DESIGN ADVICE REQUEST TABLE OF CONTENTS

Property ID: R140534, R140535, R140563
Address: 105 and 135 NW Park Avenue

CASE FILE	EA 21-068595 DA
WHEN	Thursday, August 19, 2021 @ 1:30 PM <i>(This is the hearing start time –see Commission agenda for estimated project start time.)</i>
WHERE	ONLINE: Link to drawings is available at www.portlandoregon.gov/bds/dcagenda
HOW	TO COMMENT: Follow instructions on the Design Commission agenda <u>or</u> email the planner at Benjamin.Nielsen@portlandoregon.gov
REVIEW BY	DESIGN COMMISSION
PROCESS	A Design Advice Request is a voluntary review process that allows the Commission to provide early feedback on a development proposal, prior to the required land use review
PROPOSAL	Design Advice Request for a proposed new 6-story (approx. 68 feet tall), 174 guest room hotel and approx. 1,900 square foot commercial/retail space. The building is proposed to be clad with brick at the ground floors and stucco on the upper stories. The ground floor will contain the hotel lobby, restaurant and bar, meeting rooms, fitness space, and the future commercial/retail space, as well as back of house areas. One Standard B loading space is proposed with access off NW Davis

Required Building Lines, Standards for the Park Blocks

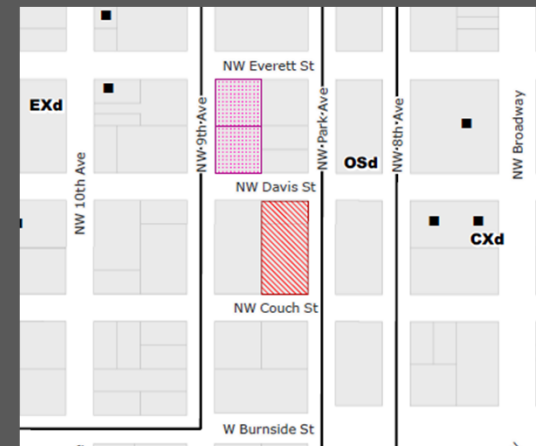
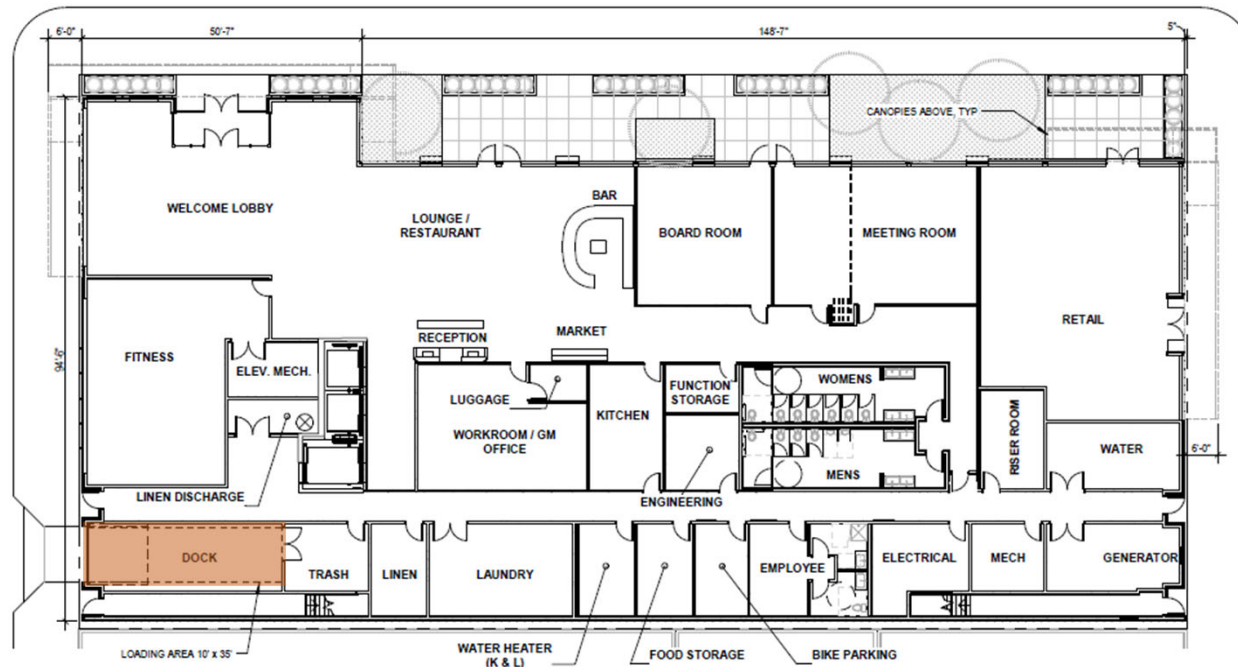
The Proposal: The lot line is 200 feet long, but only 148'-7" of the building is proposed to be set back (approximately 74.3% of the lot line length). The depth of the setback proposed, however, is approximately 15 feet.

Required setback

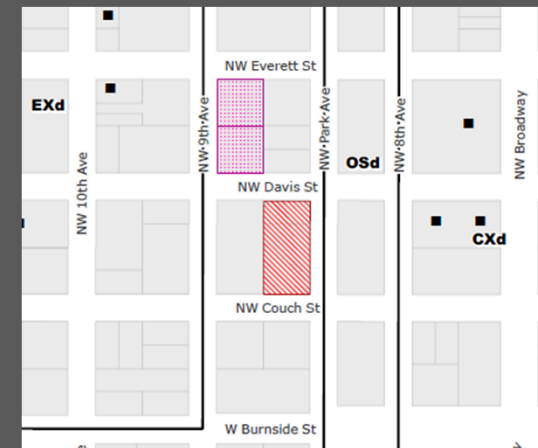
The code required setback creates an unusual situation compared to the rest of development along the North Park Blocks, with the exception of the Customs House, where development generally abuts the sidewalk edge at the lower stories of existing buildings.

Well-integrated setback area

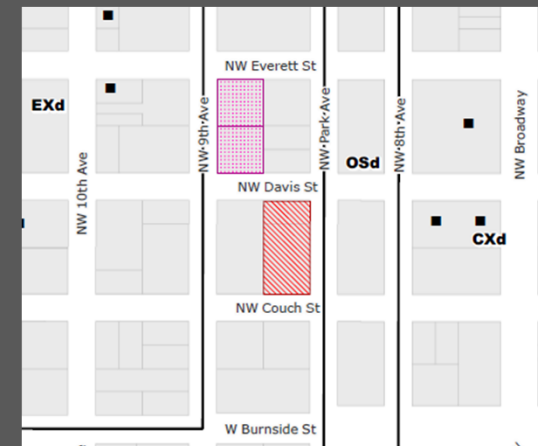
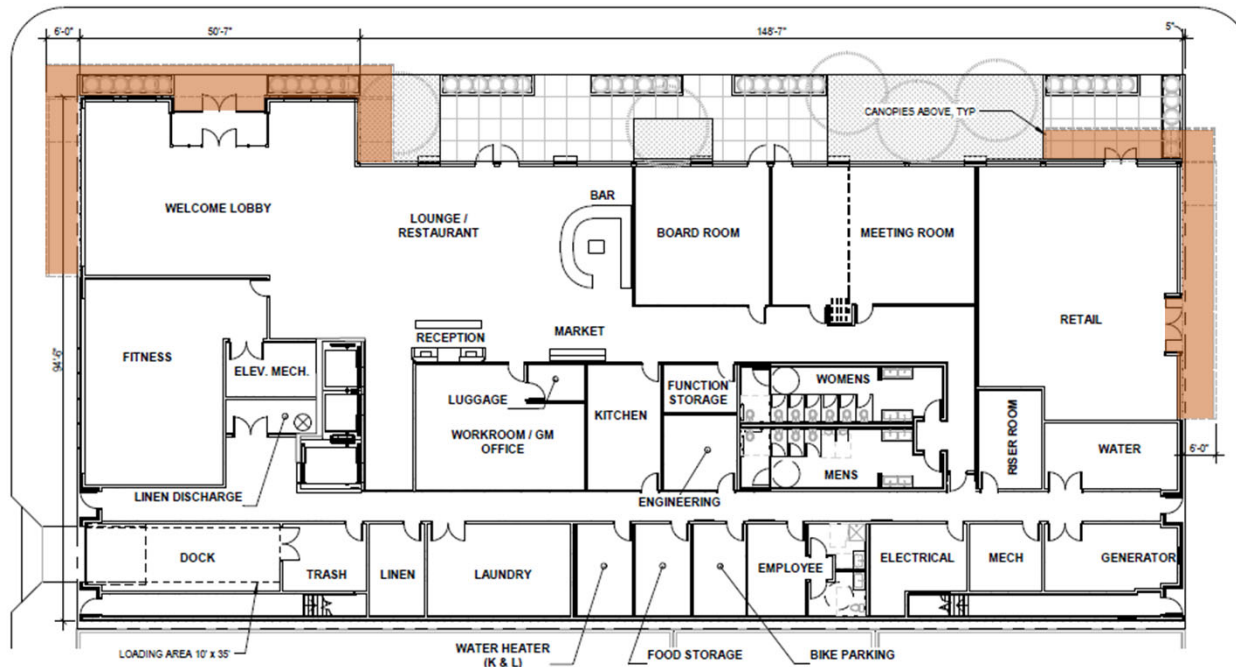
The required setback area and landscaping could help to further integrate the site within its North Park Blocks context, though the current landscape design is not yet developed enough to understand its true character. Landscape spaces shouldn't be treated as left-overs, but should be well-integrated semi-public spaces.

The setback area will contain trees and planters, although a greater level of enclosure could be provided by incorporating an open trellis or arcade structure along this area.

Lack of articulation along NW Davis

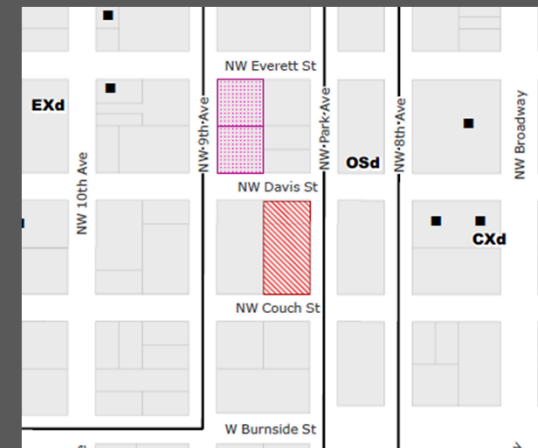
While the frontage along NW Davis St has active uses for most of its length, it is otherwise unarticulated.

Generator room and vent

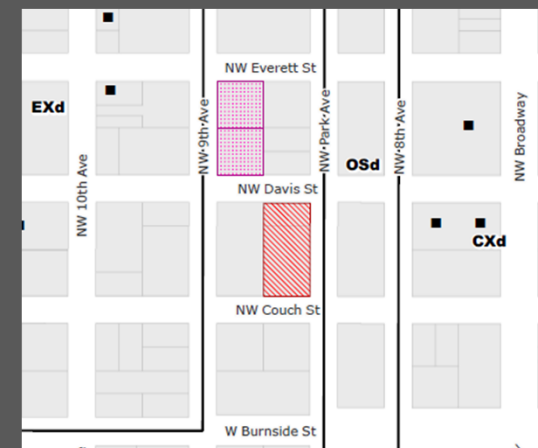
A generator room and large vent faces NW Couch St. A single loading space faces NW Davis St. The generator should be located on the roof, or at the very least, the vents should be located away from the pedestrian realm.

Projecting window bay

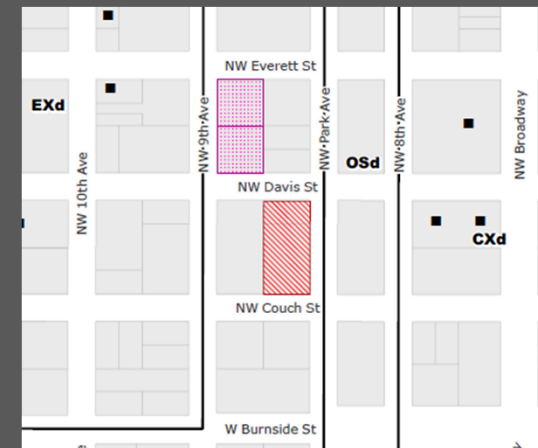
The projecting window on the south elevation deviates from the overall design and should be more integrated or removed from the proposal.

Vents

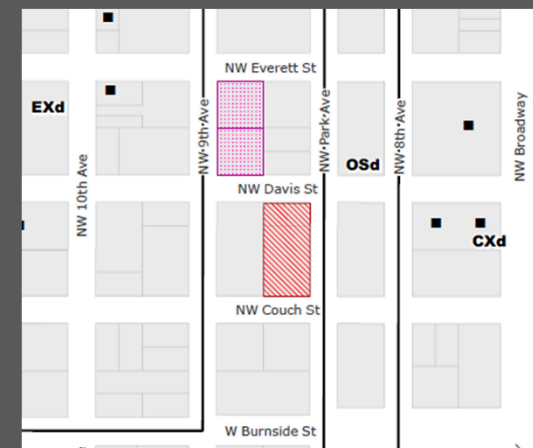
Proposed vents on the upper stories seem oversized and unnecessarily visually dominant on all three frontages.

Required Building Lines, Standards for the Park Blocks

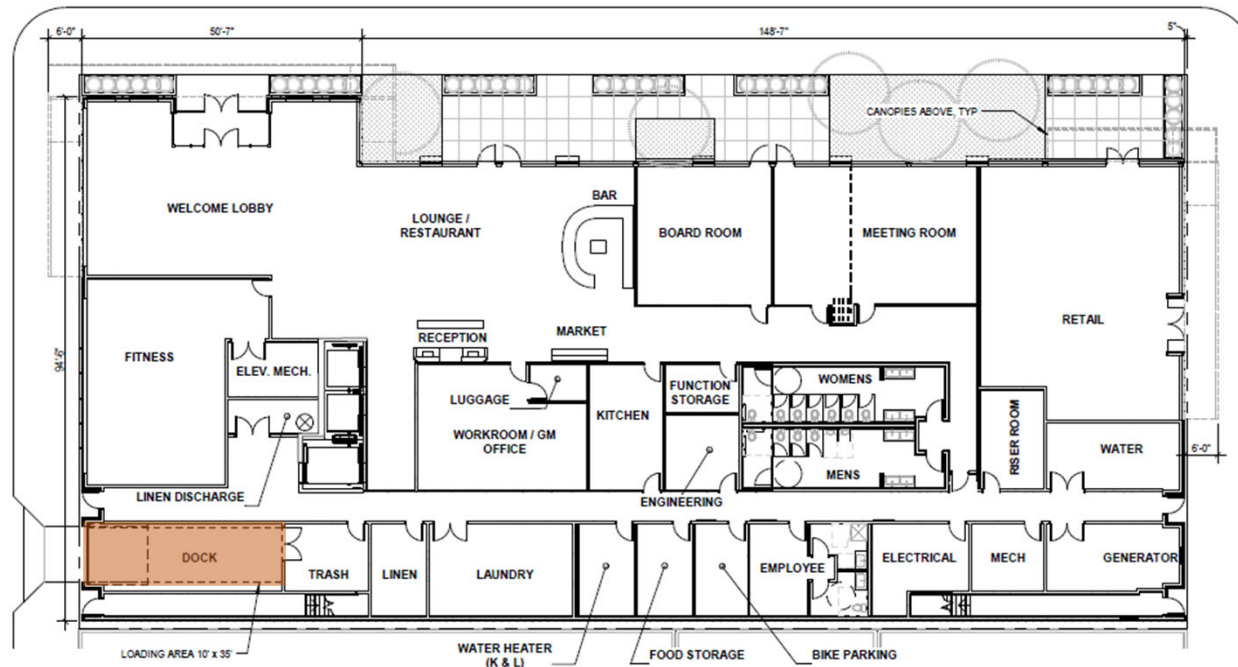
The Proposal: The lot line is 200 feet long, but only 148'-7" of the building is proposed to be set back (approximately 74.3% of the lot line length). The depth of the setback proposed, however, is approximately 15 feet.

The extra depth could be beneficial in providing more useful area for pedestrians and larger plants. Ultimately, the setback area's design, detailing, and integration with the building and surrounding pedestrian realm will factor into consideration as to whether this potential Modification is approvable.
